Year 2 Monitoring Report

APPLE VALLEY PROJECT

NCDMS Project #100063 (Contract #7531)
USACE Action ID: SAW-2018-01150
DWR Project #20181028

RE: Apple Valley Site: Year 2 Monitoring Report

Current Conditions Plan View

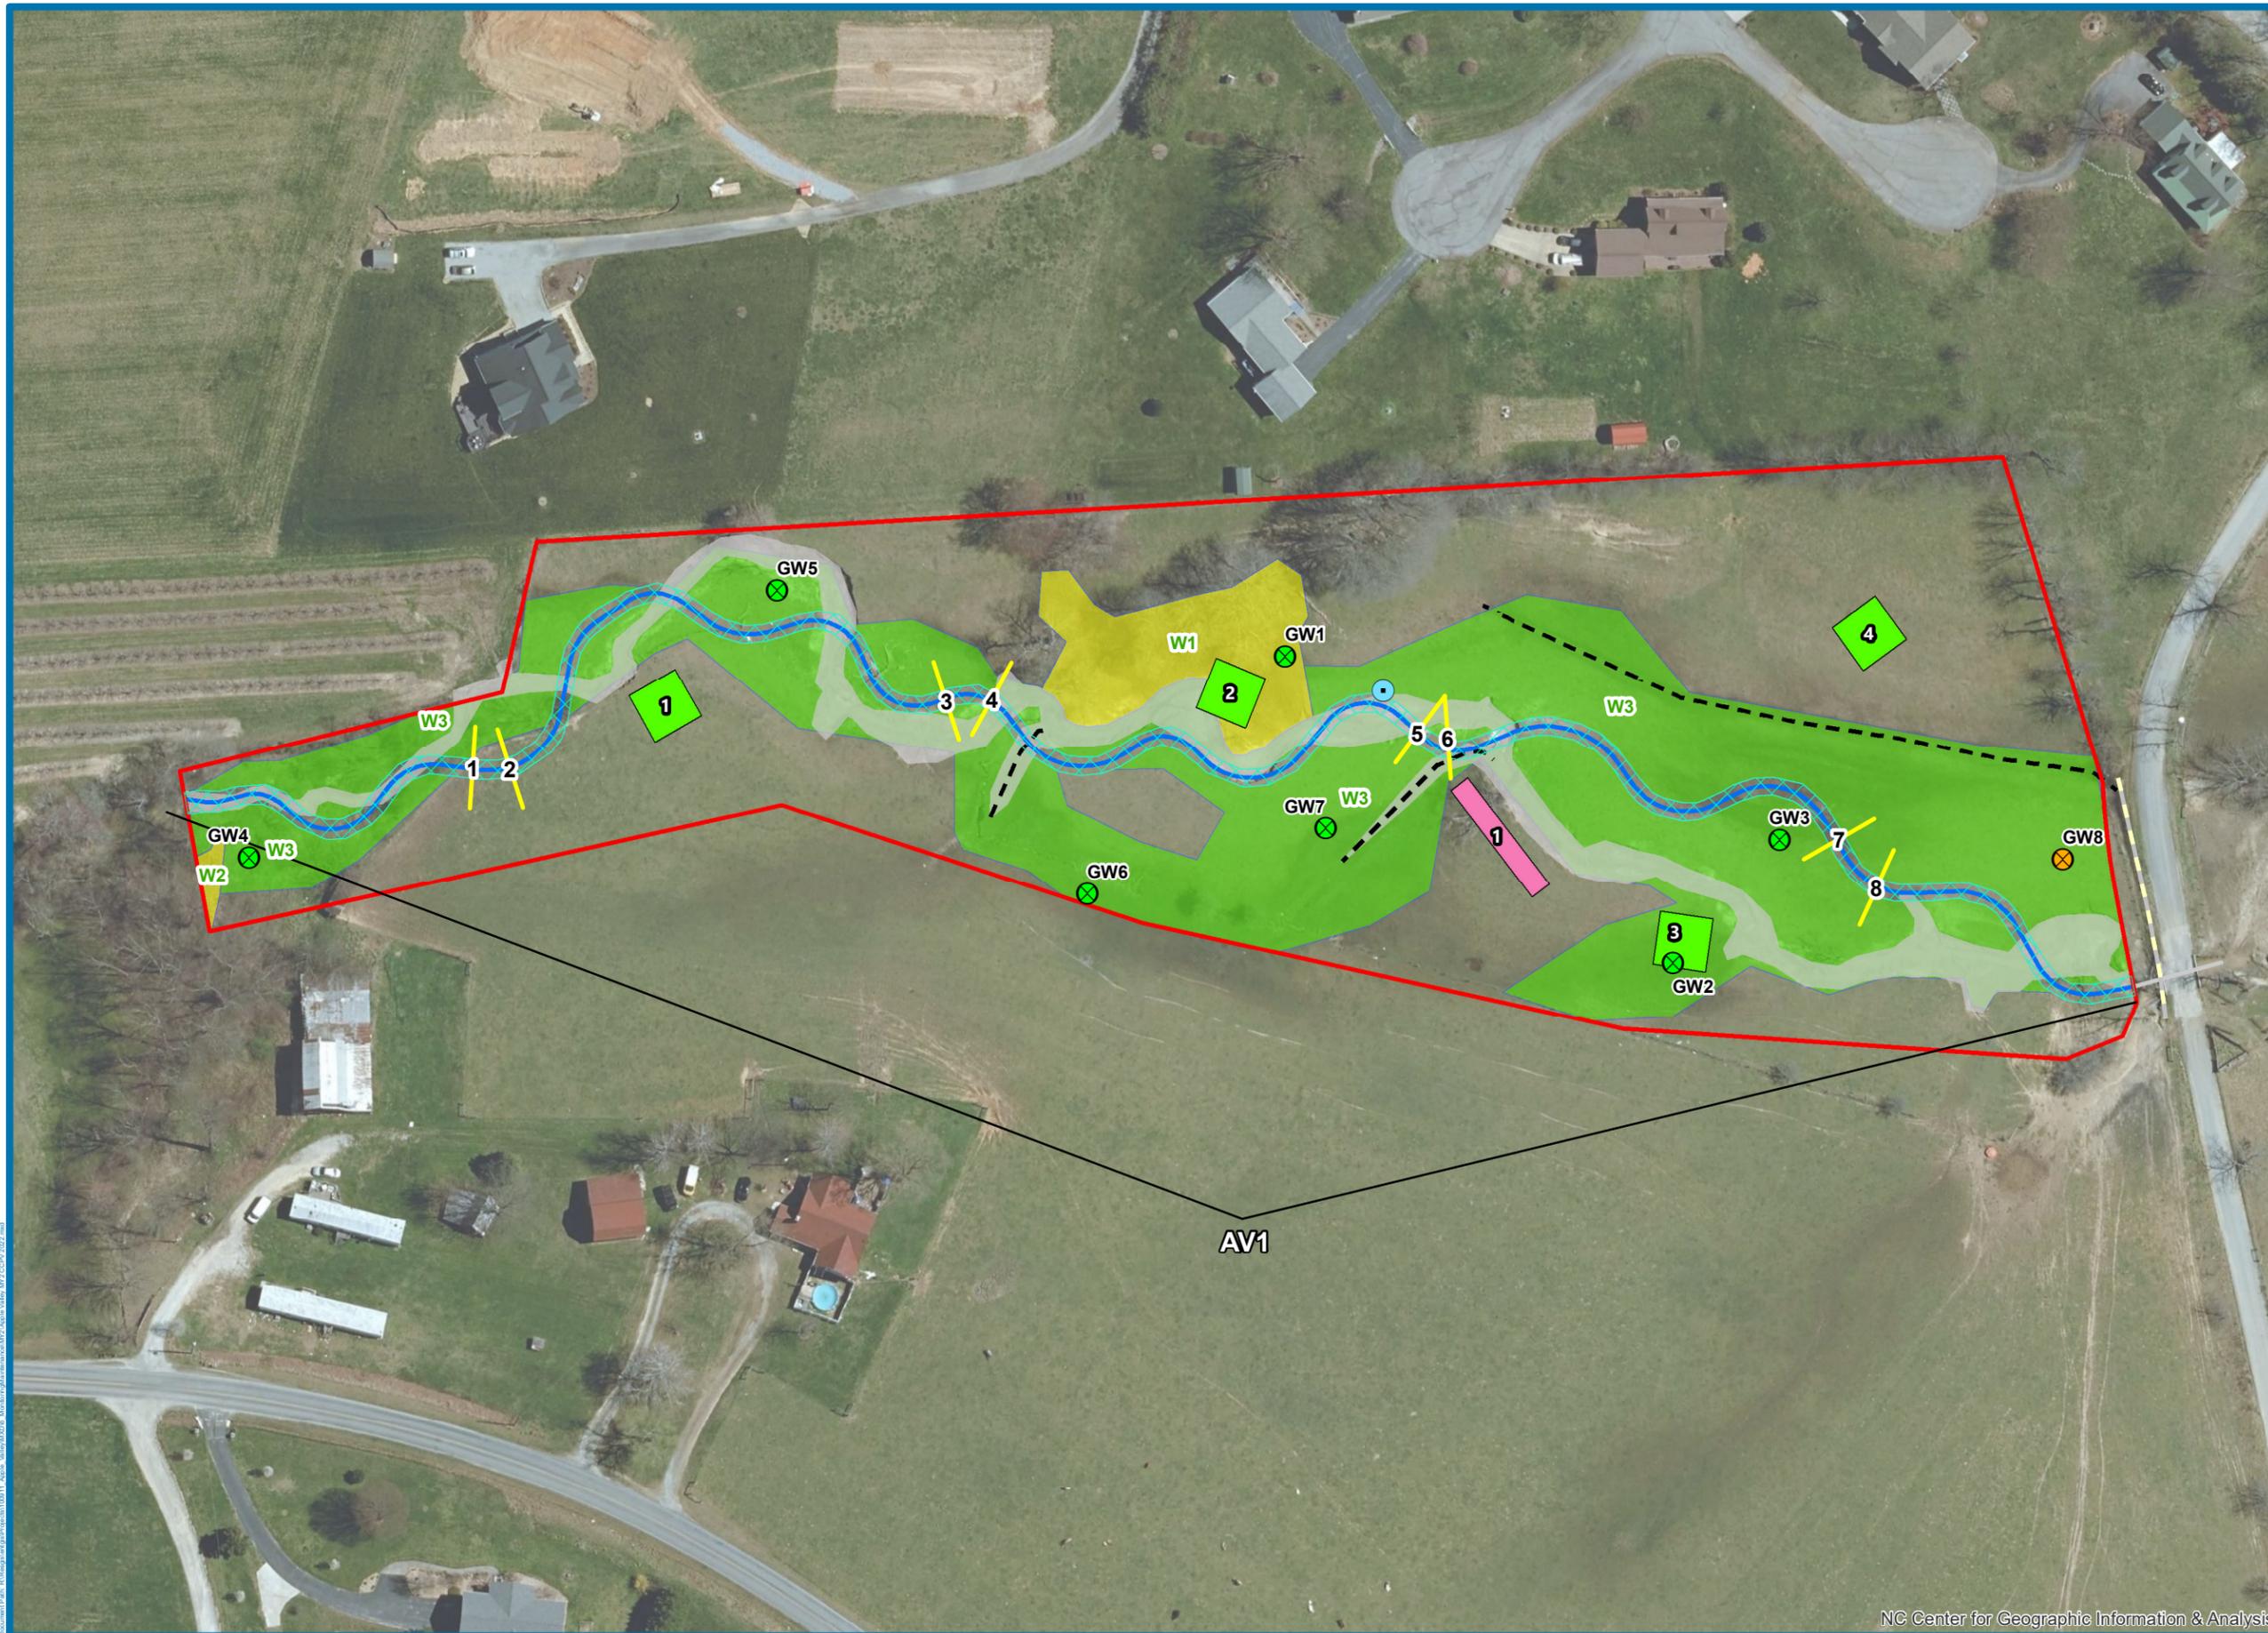
GWG 8 has not met success criteria for the first two years of the monitoring period. It is noted that a nearby ditch may be affecting the performance. This gauge is the lone gauge for the reestablishment area on the east side of the creek (south section). Does RES expect the hydrology to improve in future years, given the proximity to the ditch? Does the area to the immediate north of GWG 8 (away from the ditch) appear to have better hydrology? In general, how does RES plan to monitor and /or potentially adaptively manage the wetlands in this area in the future?

Rain data: The onsite rain gauge that was in the MY01 report is missing from the MY02 CCPV. Table 13 (footnote) indicates that the on-site rain gauge malfunctioned in 2021 and was replaced in May 2022, however onsite precipitation data is entirely missing from Table 12, and the rain gauge symbol no longer appears on the CCPV. But the onsite gage data is shown on the GWG graphs for the entire calendar year (2022). Please review the rain data, edit/update as necessary, and clarify how RES plans to collect/report rain data moving forward, particularly given the GW8 gauge results.

The CCPV indicates that in-channel vegetation was treated in 2022. The text indicates that a water-safe herbicide was used to treat in channel vegetation, however it is not clear what the in-channel target species was. Please provide a clearer description of the stream channel vegetation, how it formed, and why it was treated, and how RES plans to potentially proceed with in channel treatments; keep in mind that active channel vegetation maintenance beyond MY02 needs to be pre-approved with the IRT. There is a photo in the report of the stream vegetation, but the vegetation looks more like streambank vegetation; other descriptive photos might help.

CCPV Map is labelled "Maintenance Map". Please rename to CCPV.

[RES plans to create a minimally invasive ditch plug, using coir logs and wooden stakes, in order to decrease the amount of water diversion through this section of wetland and ultimately work to improve hydrology for GW8. A plug was originally proposed in the design plans; however, the wetland along the south side of the project was exceedingly wet during construction, therefore the ditch plug installation was left as lower priority maintenance, as necessary. If hydrology does not improve for GW8, RES will install an additional](#)

groundwater gauge further north from the existing gauge. As stated in the report, there are several vegetative wetland indicators surrounding GW8.

On-site precipitation for this Project is no longer being monitored, via rain gauge, due to continued complications with rain gauge function, including clogged sensors/water catchment, battery life, and overall accuracy issues; therefore, data taken from the Fletcher, NC Asheville Faa AP gauge, located about 10 miles northwest of the site, has been used and will continue to be used for the remaining life of the Project. All erroneous notes in the tables/graphs have been revised to state this.

In-channel vegetation was treated in response to a comment from DMS during MY1. The exact species was not confirmed, but potential species were provided in the MY1 comment response memo (*Iris virginica*, *Panicum virgatum*). The species could have been introduced via the adjacent landscapes surrounding the easement, or seed could have established in the channel, flowing in from the 277-acre drainage area. While it did not pose an immediate threat, as a preventative, early-stage measure, the in-channel vegetation was treated. As time goes on, it is expected that surrounding trees, both livestakes and bareroots, will continue to grow along the banks, shading out further in-channel vegetation establishment.

This correction has been made.
